ADDENDUM NO. 3
SEWER SYSTEM IMPROVEMENTS
CONTRACT 18-01
15 MG PRESTRESSED CONCRETE STORAGE TANK
PADUCAH MCCRACKEN JOINT SEWER AGENCY
PADUCAH, KENTUCKY
WAUFORD PROJECT NUMBER 2081
CLEAN WATER REVOLVING LOAN FUND #A12-08

Date of Addendum: Friday, June 15, 2018

- CONSTRUCTION NOTES:**
- SEE "GENERAL NOTES" AND "LEGEND", SHEET 1.
 - ALL DUCTILE IRON PIPE SHALL BE SPECIALLY LINED AS SPECIFIED.
 - ALL MECHANICAL JOINT FITTINGS SHALL UTILIZE MEGALUG RETAINER GLANDS.
 - TANK BASE SLAB THICKNESS TO BE DETERMINED BY THE CONTRACTOR.

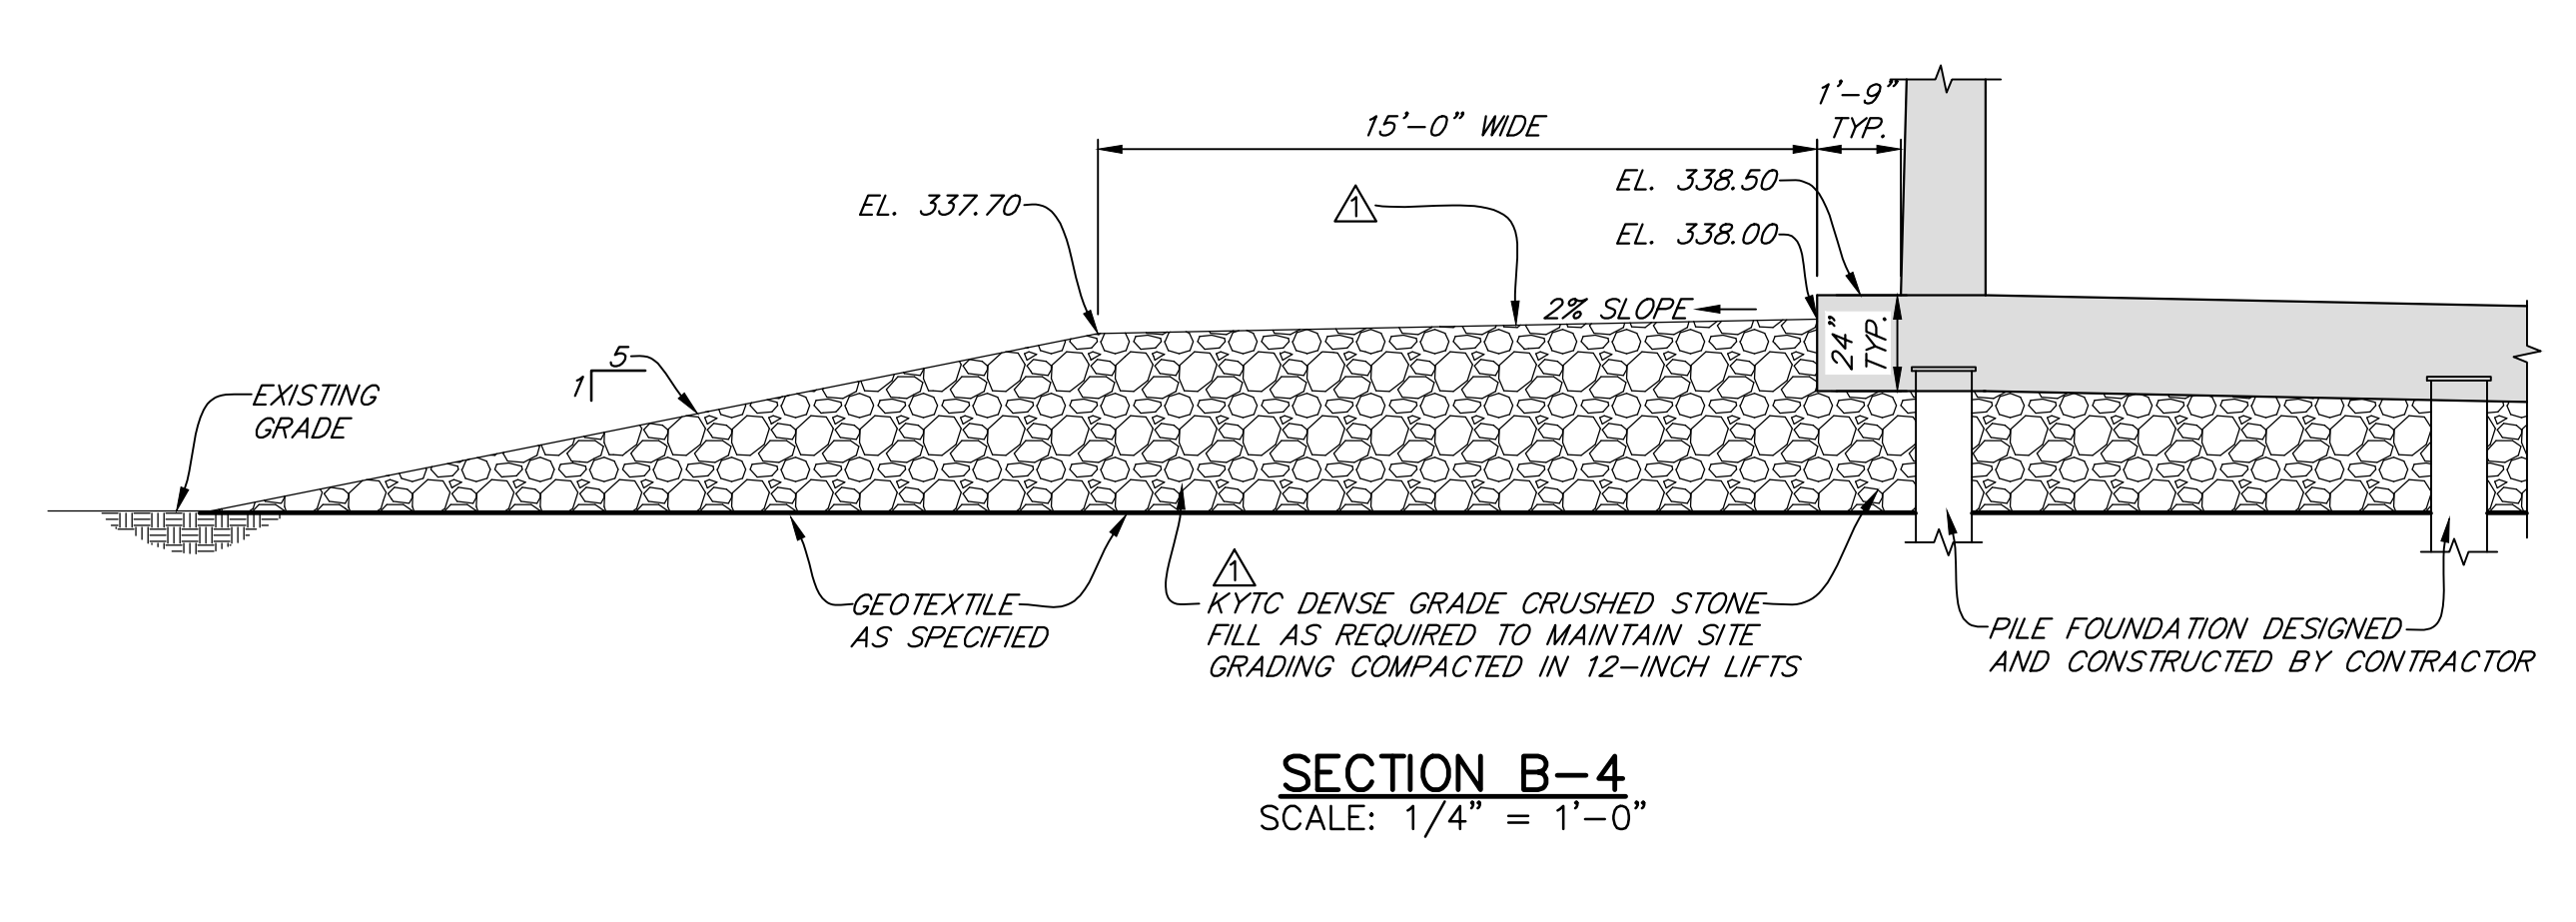
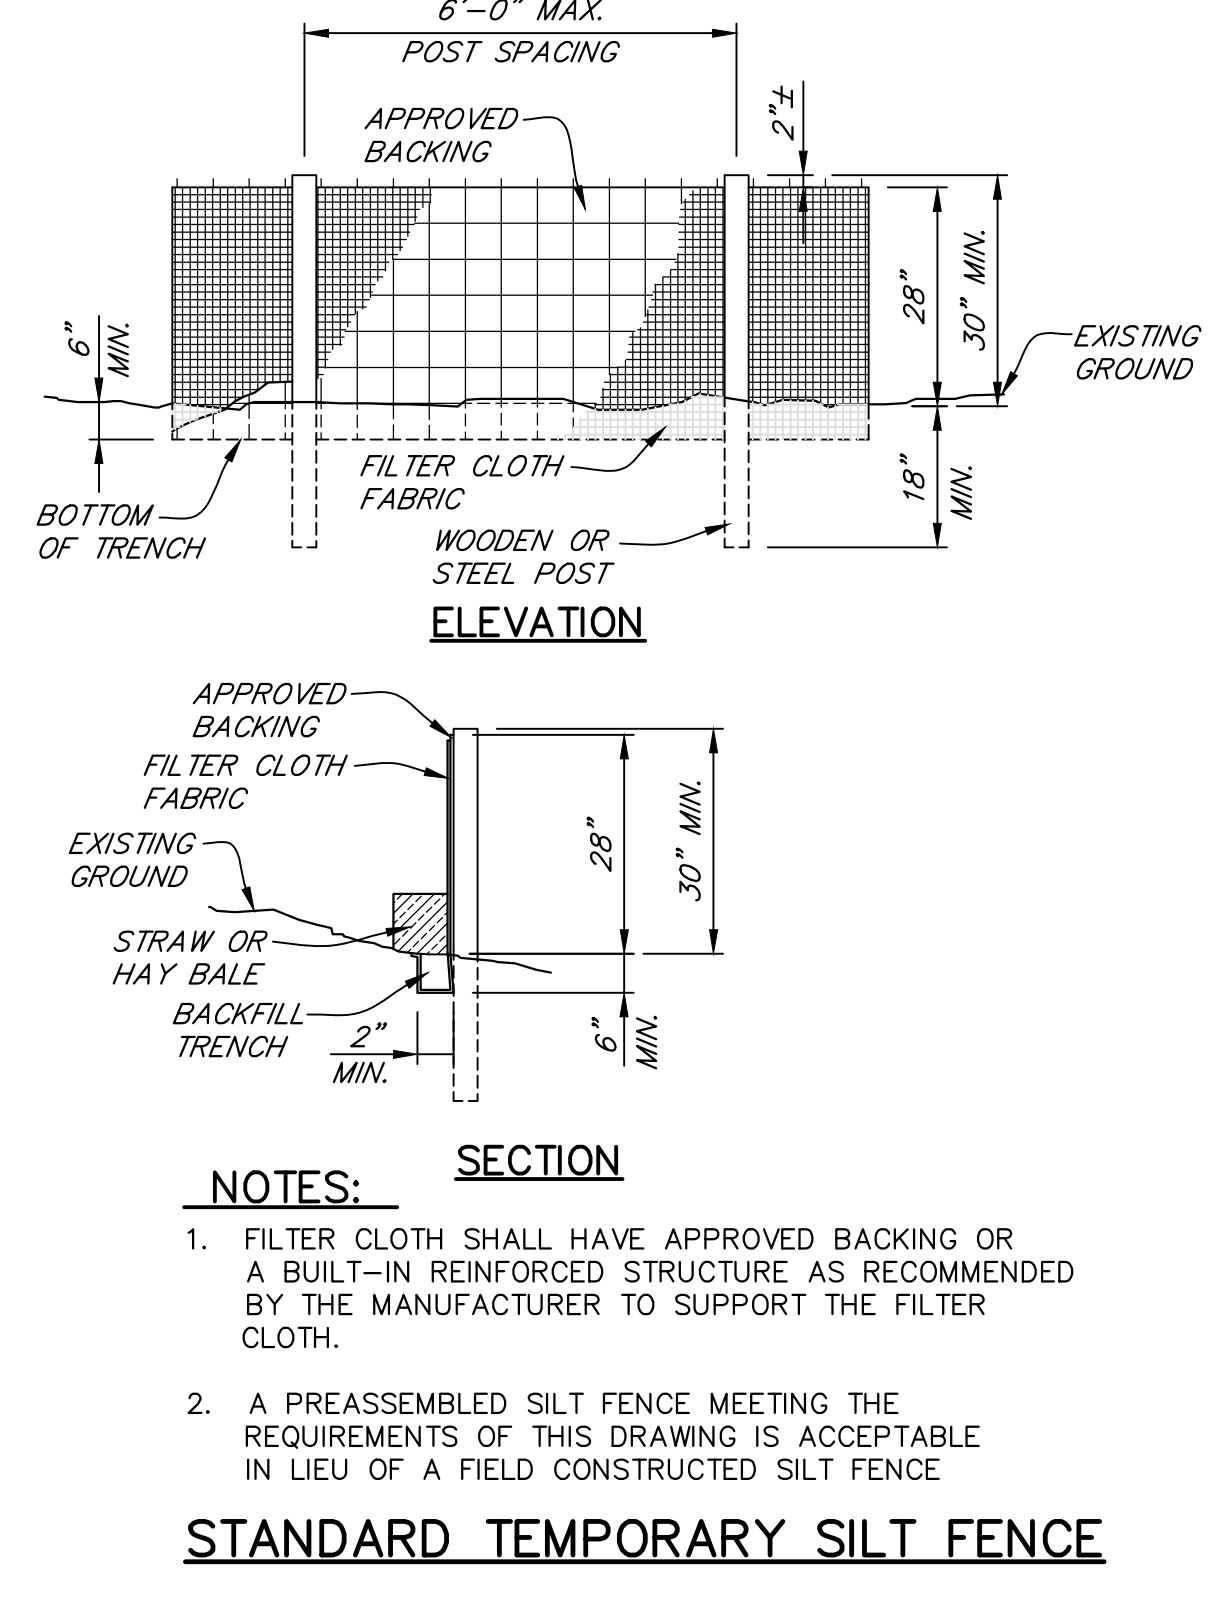
6. Plans, Sheet 4:

Revise as shown on the attached Plan sheet.
